**DESCRIPTION OF THE TOTAL SYSTEM
PERFORMANCE ASSESSMENT
AND INTEGRATION ISSUE
RESOLUTION BLUEPRINT**

**U.S. Nuclear Regulatory Commission
Contract NRC-02-97-009**

**Center for Nuclear Waste Regulatory Analyses
San Antonio, Texas**

April 2002

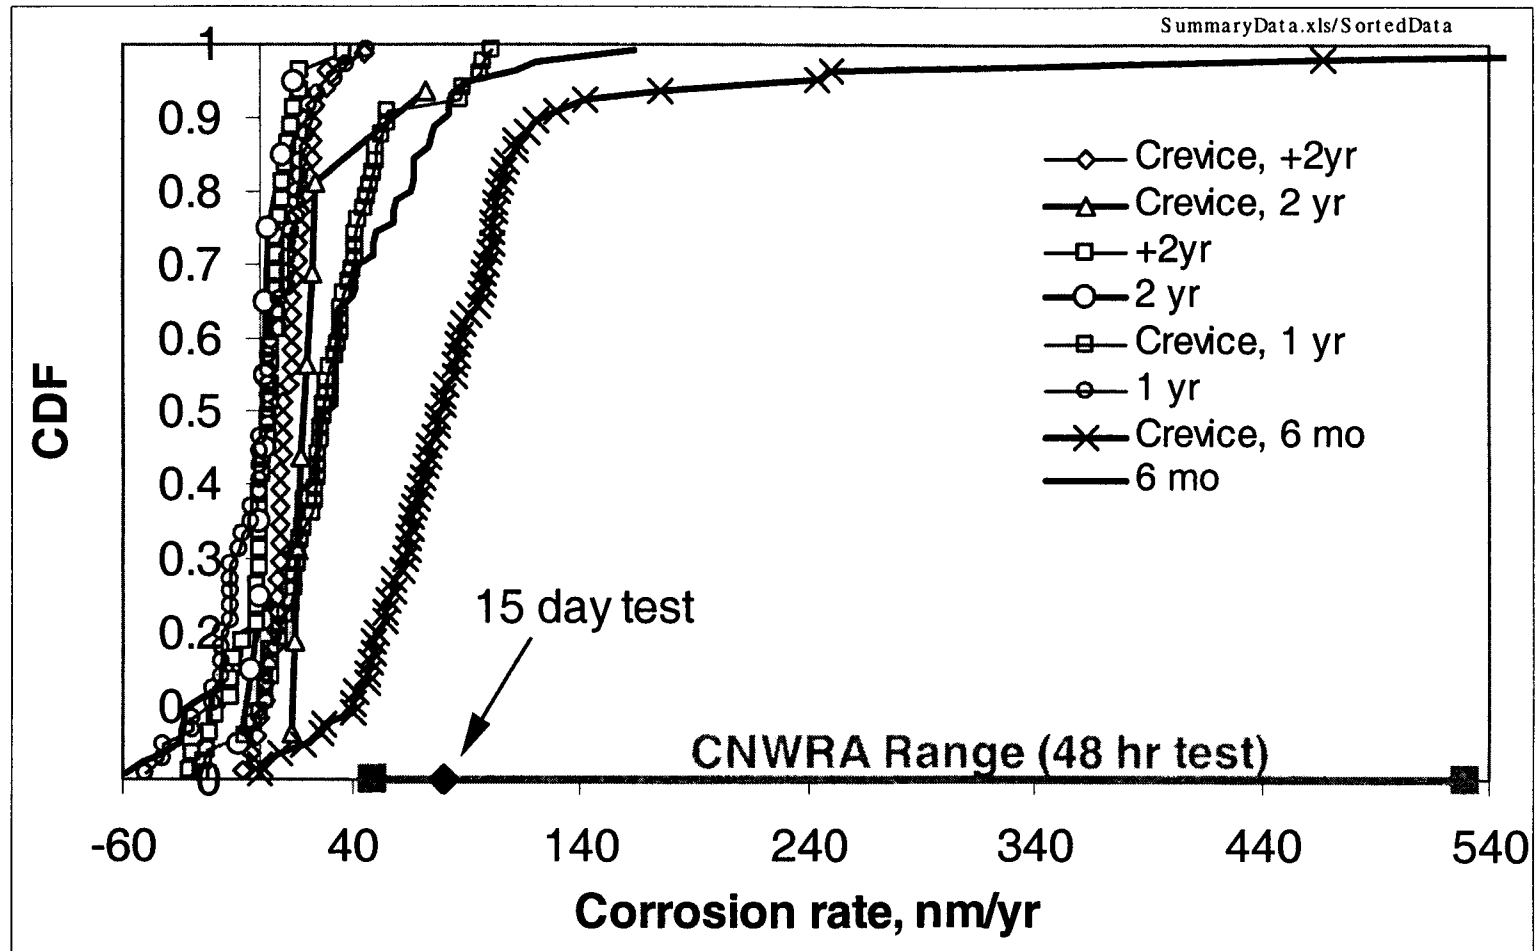
Crevice samples yield higher corrosion rates, why?

- Equation to compute corrosion rates (Equation 3-15 in WP Deg PMR, 2000): $r = w/(A \rho t)$
 - w , measured weight loss; A , reference surface area (30.65 and 57.08 cm² for weight loss and crevice samples, respectively); ρ , alloy density; t , time of test.
- Is it possible that enhanced corrosion rates as a result of a less protective film are occurring in the crevice area? Is the equation adequate to compute corrosion rates if there are localized regions of enhanced dissolution?

Results

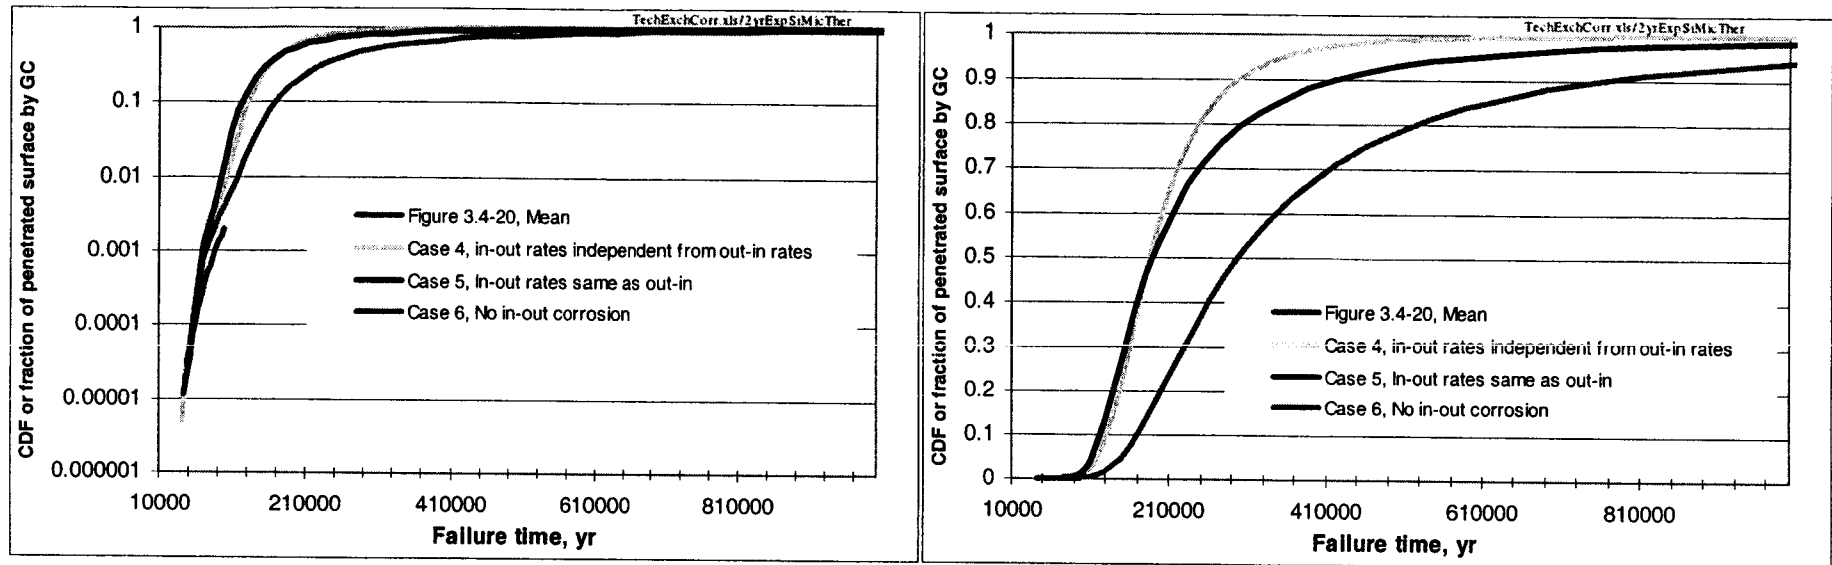
The results seem consistent. Estimates of the fraction of WP surface penetrated by general corrosion are slightly above DOE results reported in the TSPA-SR, p. F3-62, up to a factor of ~10 at 100,000 yr.

Figure 3.4-19. Degradation Profiles for Time to First Failure: Drip Shield Patch, Waste Package Crack, Waste Package Patch

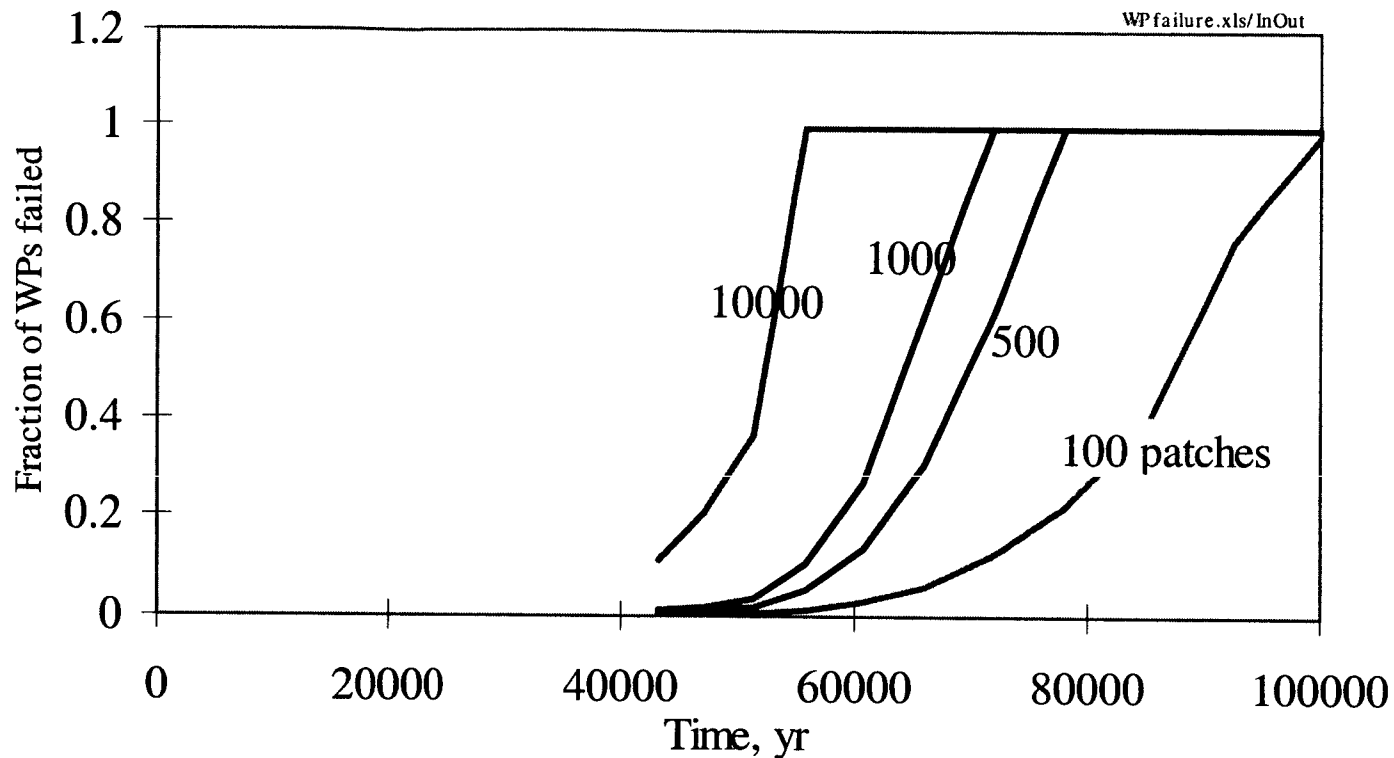
Curves in this figure (from TSPA-SR, TDR-WIS-PA-000001 Rev 00 ICN 01), are not well-defined.

The fraction of WPs failed (1st patch penetration) is an ill-defined quantity. It depends on the number of assumed patches on the WP surface.
